HISTORIC AND DESIGN REVIEW COMMISSION

HDRC CASE NO: 2022-271
ADDRESS: 1933 W MULBERRY AVE
LEGAL DESCRIPTION: NCB 1944 BLK 22 LOT 9
ZONING: R-6, H
CITY COUNCIL DIST.: 7
DISTRICT: Monticello Park Historic District
APPLICANT: Jennifer Stimmel/Statewide Remodeling.
OWNER: Rudy Blanco/BLANCO RUDY L & GUADALUPE
TYPE OF WORK: Window replacement
APPLICATION RECEIVED: May 04, 2022
60-DAY REVIEW: Not applicable due to City Council Emergency Orders
CASE MANAGER: Rachel Rettaliata

REQUEST:

The applicant is requesting a Certificate of Appropriateness for approval to replace ten (10) original wood windows with vinyl windows.

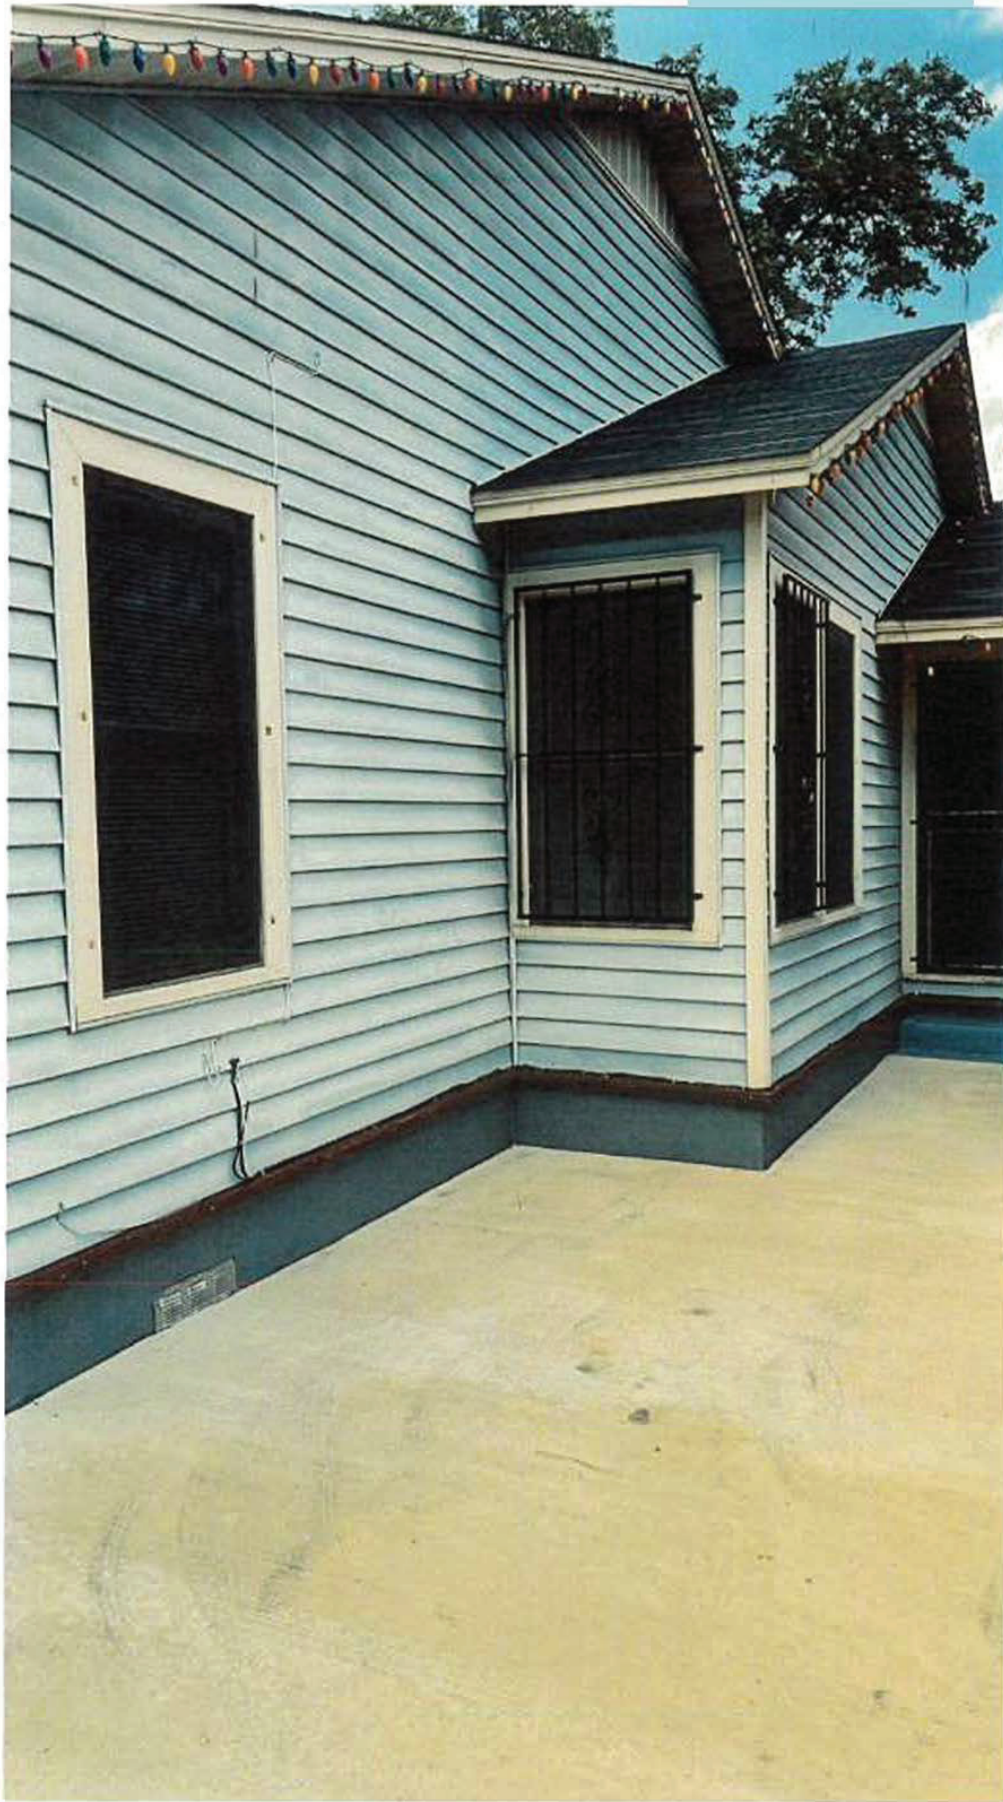
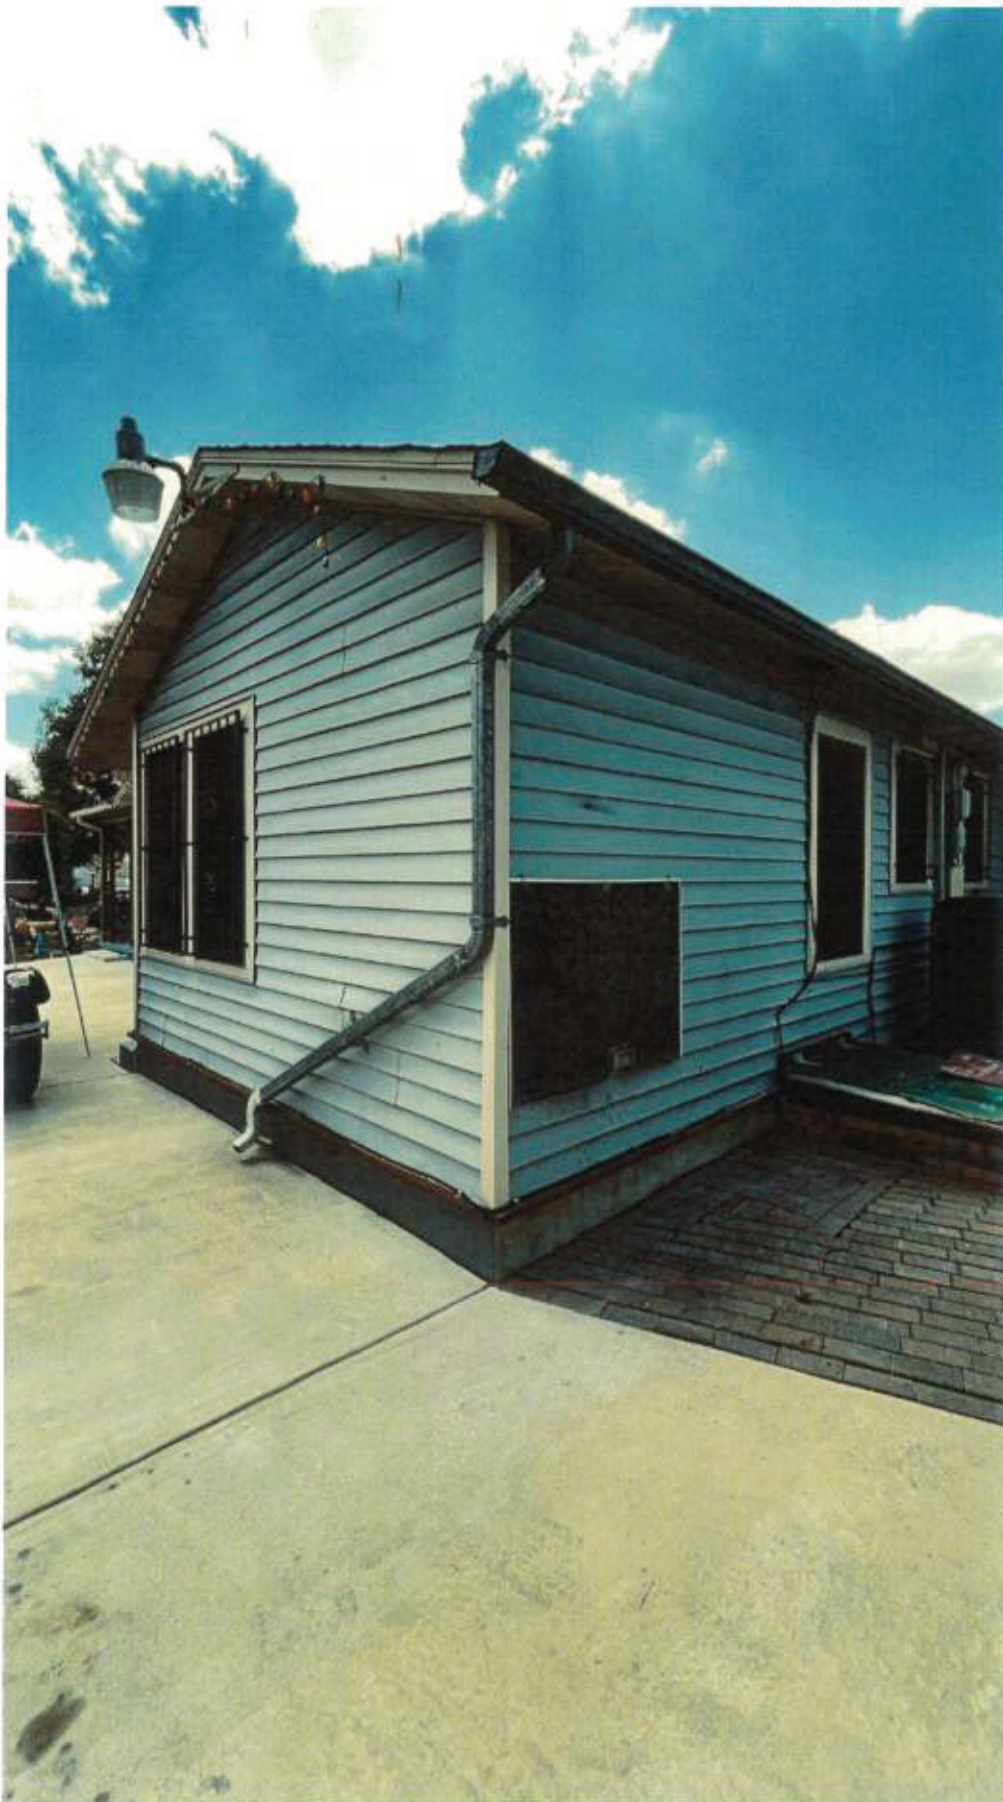
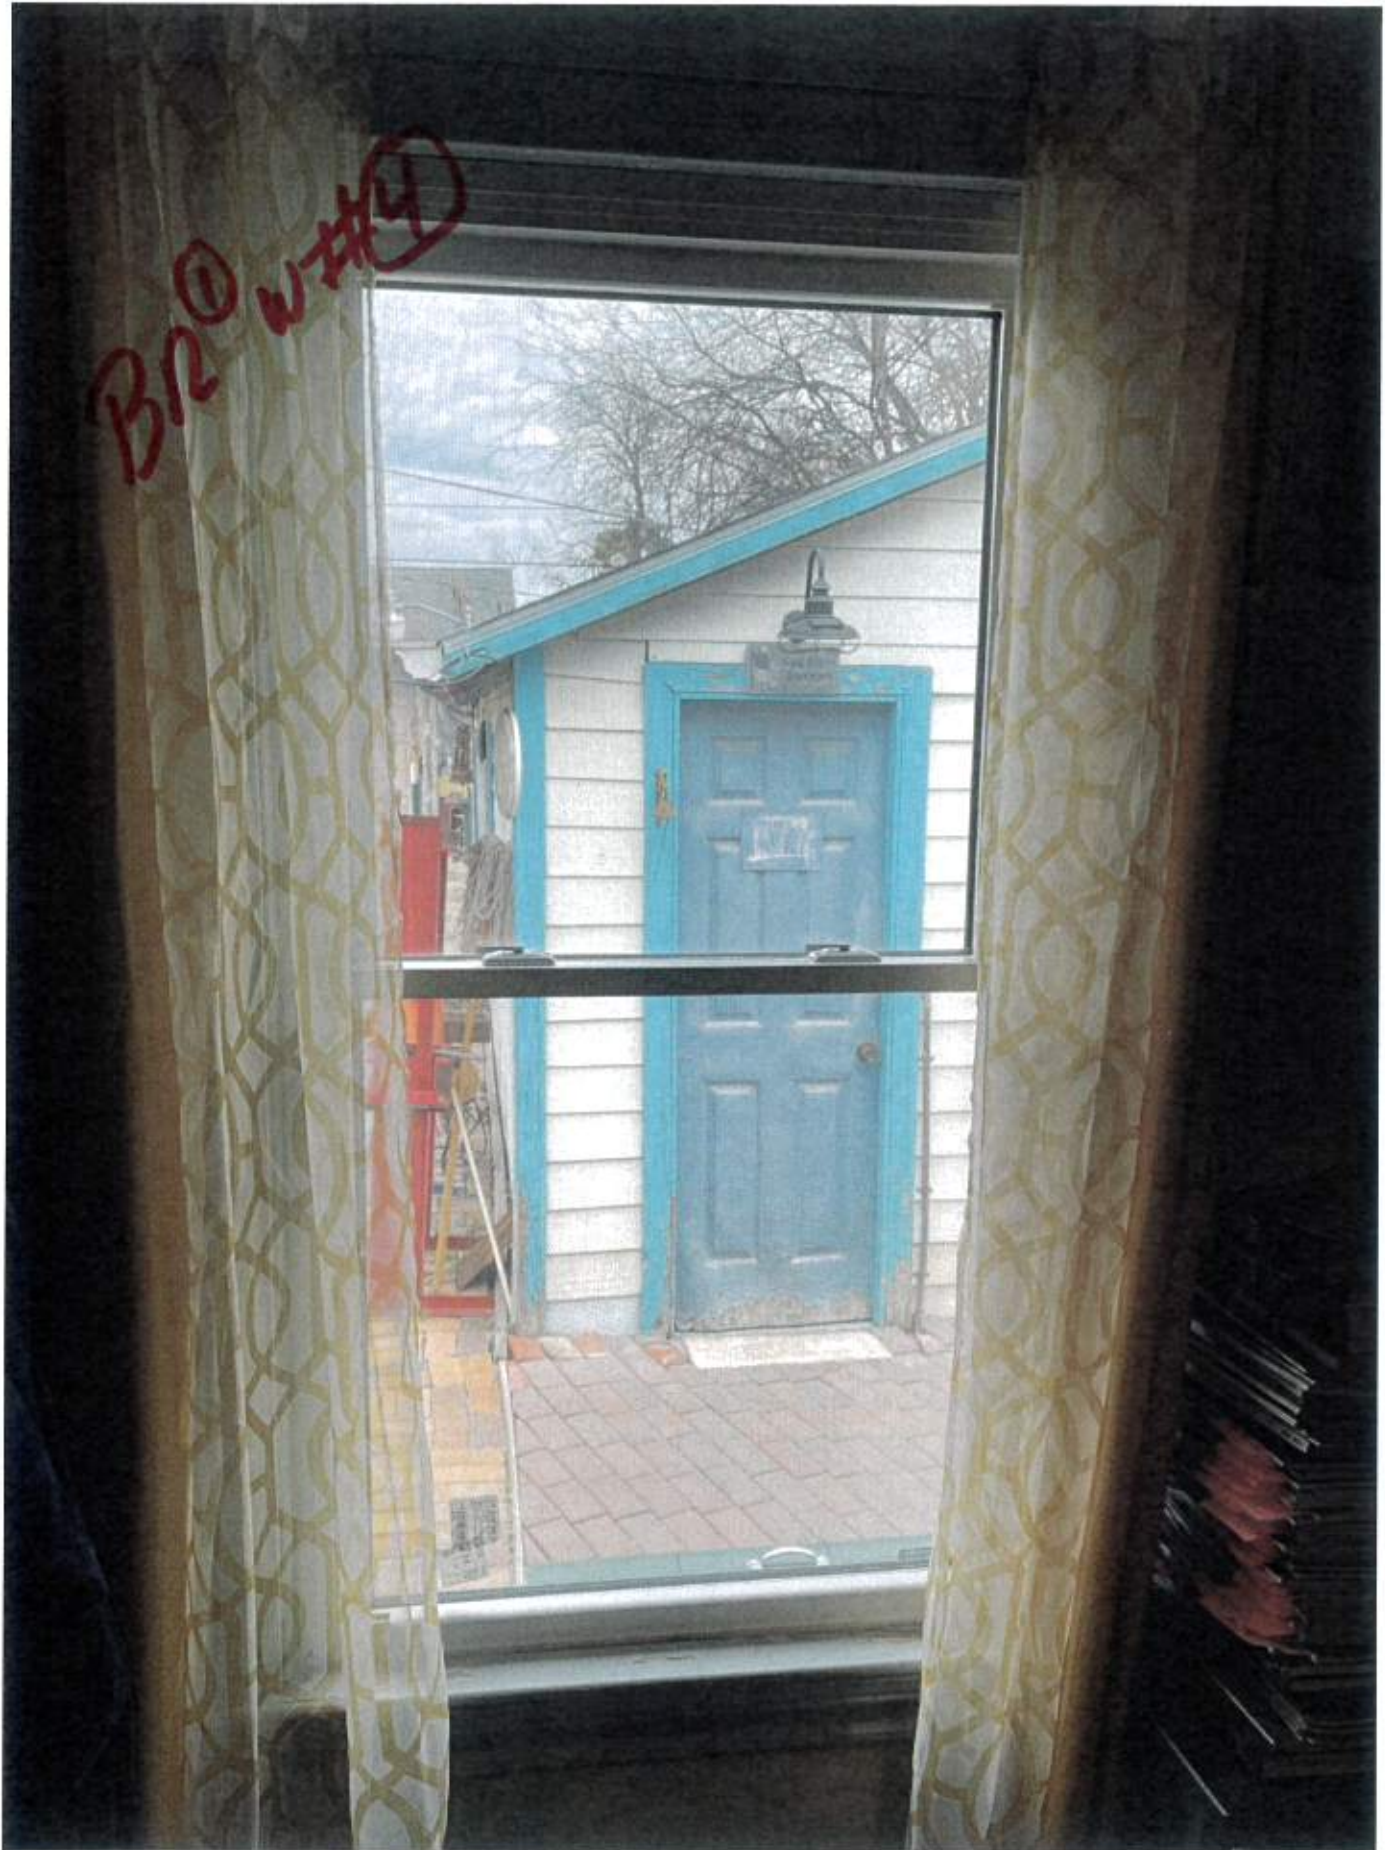
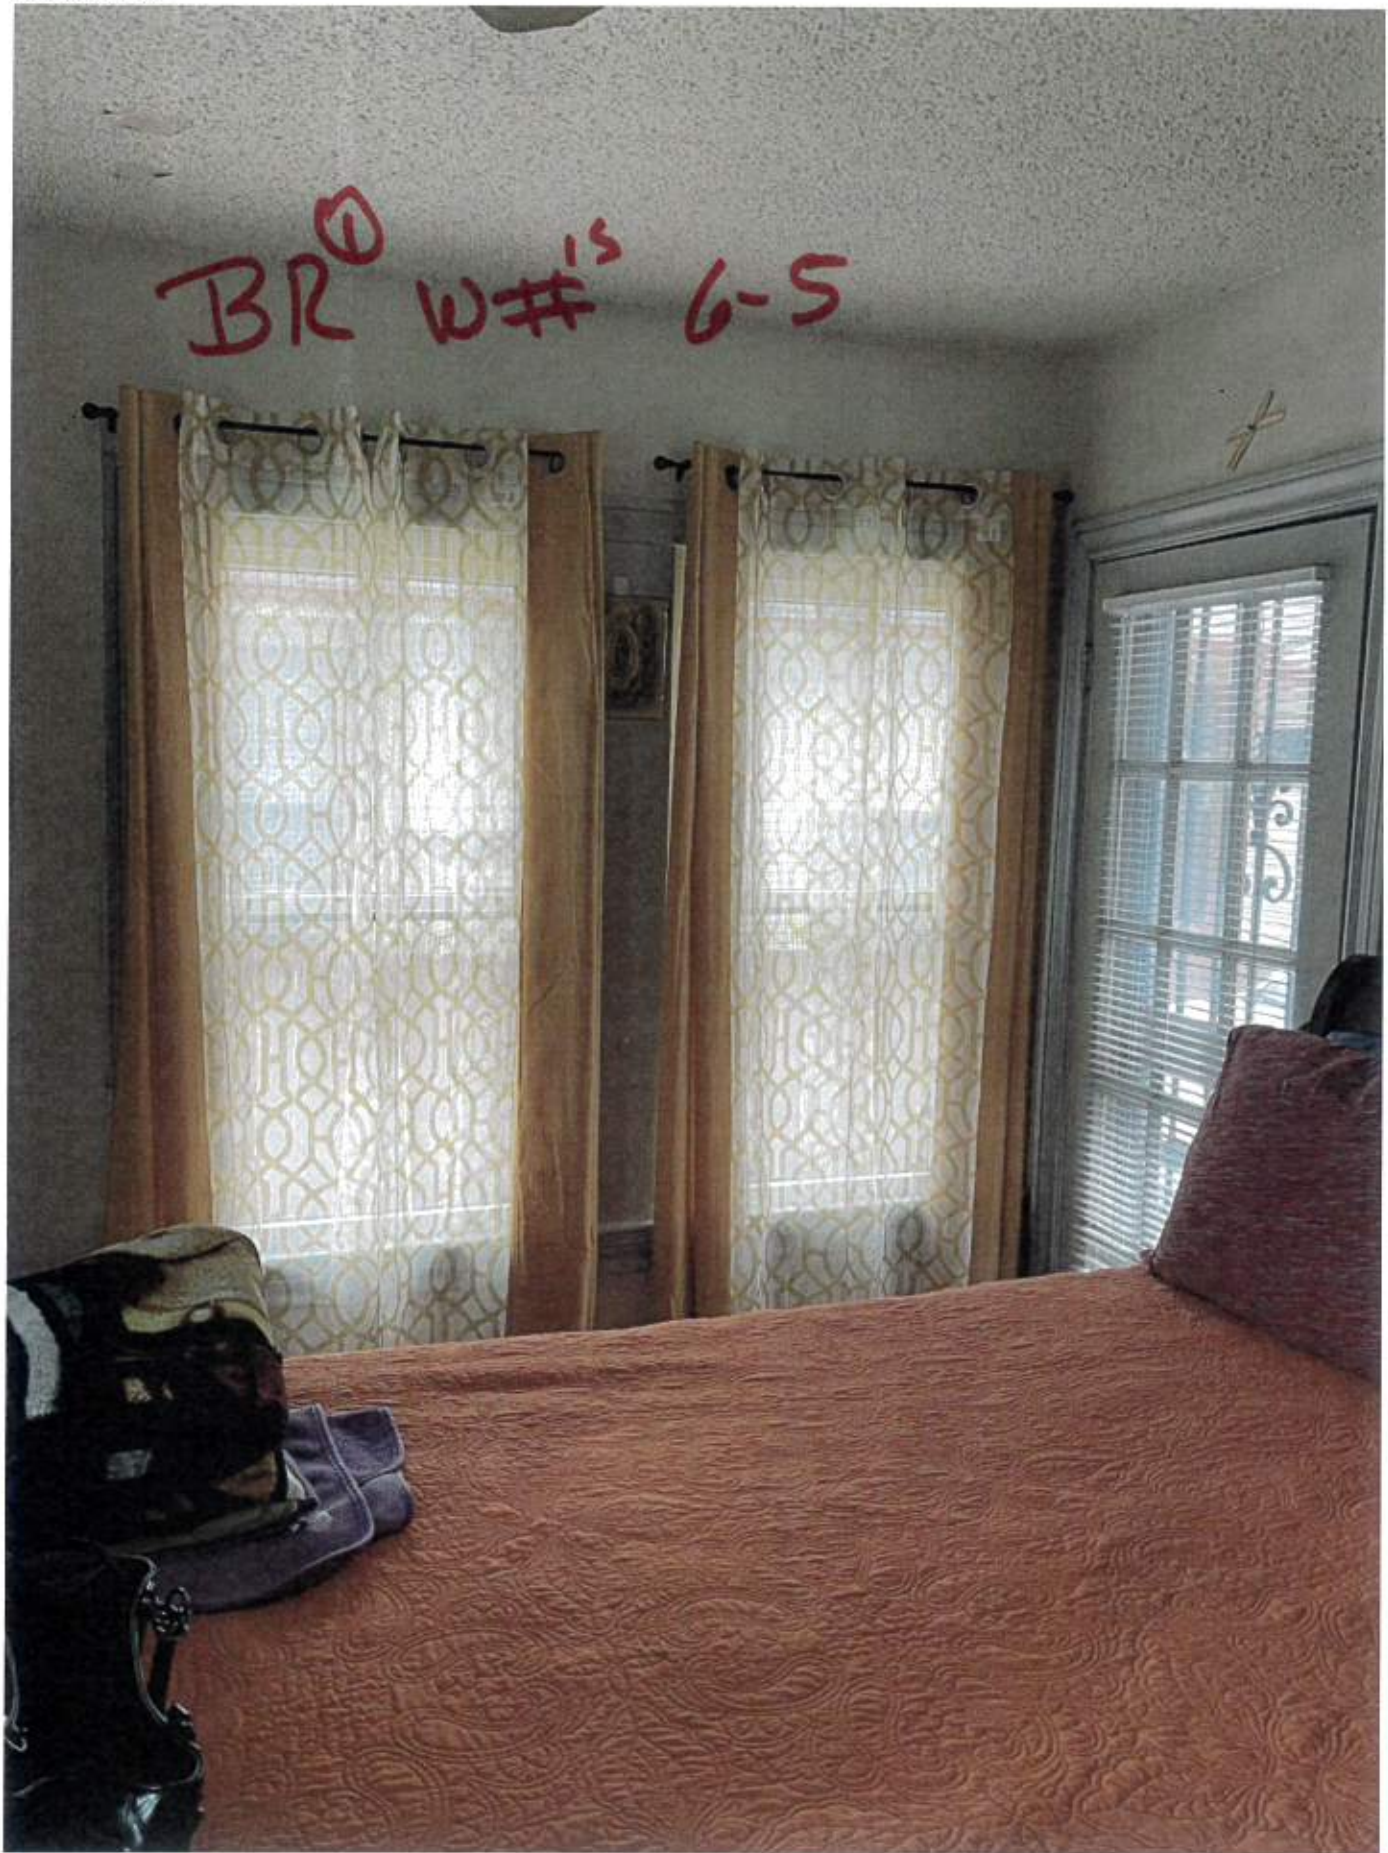
- c. WINDOW REPLACEMENT: EXISTING CONDITION – Staff conducted a site visit on May 5, 2022, and observed the following conditions on the remaining original wood windows: damaged and peeling or chipping paint, broken or missing cords, and loose or broken glass. Some of the existing windows may require reglazing or the reworking of the sashes. The windows do not show signs of significant wood rot, wood damage, or severe deterioration. Staff finds that all remaining wood windows are in repairable condition, with most requiring

- f. **WINDOW REPLACEMENT** – The applicant has proposed to replace ten (10) existing wood windows with vinyl replacement windows. According to the Historic Design Guidelines, wood windows should be repaired in place and restored whenever possible, unless there is substantial evidence that the windows are deteriorated beyond repair. Guideline 6.B.iv for Exterior Maintenance and Alterations states that new windows should be installed to match the historic or existing windows in terms of size, type, configuration, material, form, appearance, and detail when original windows are deteriorated beyond repair. As noted in finding b, staff finds that the windows are in repairable condition, with a majority of them being covered and protected over the past few decades by exterior screens, and that the replacement product is not appropriate or consistent with the Guidelines.

Staff does not recommend approval based on findings a through f.

- i. That the applicant installs fully wood windows that meet staff's standard window stipulations and submits updated specifications to staff for review and approval. The windows should feature an inset of two (2) inches within facades and should feature profiles that are found historically within the immediate vicinity. Meeting rails must be no taller than 1.25" and stiles no wider than 2.25". White manufacturer's color is not allowed, and color selection must be presented to staff. There should be a minimum of two inches in depth between the front face of the window trim and the front face of the top window sash. This must be accomplished by recessing the window sufficiently within the opening or with the installation of additional window trim to add thickness. Window trim must feature traditional dimensions and architecturally appropriate sill detail. Window track components must be painted to match the window trim or concealed by a wood window screen set within the opening.
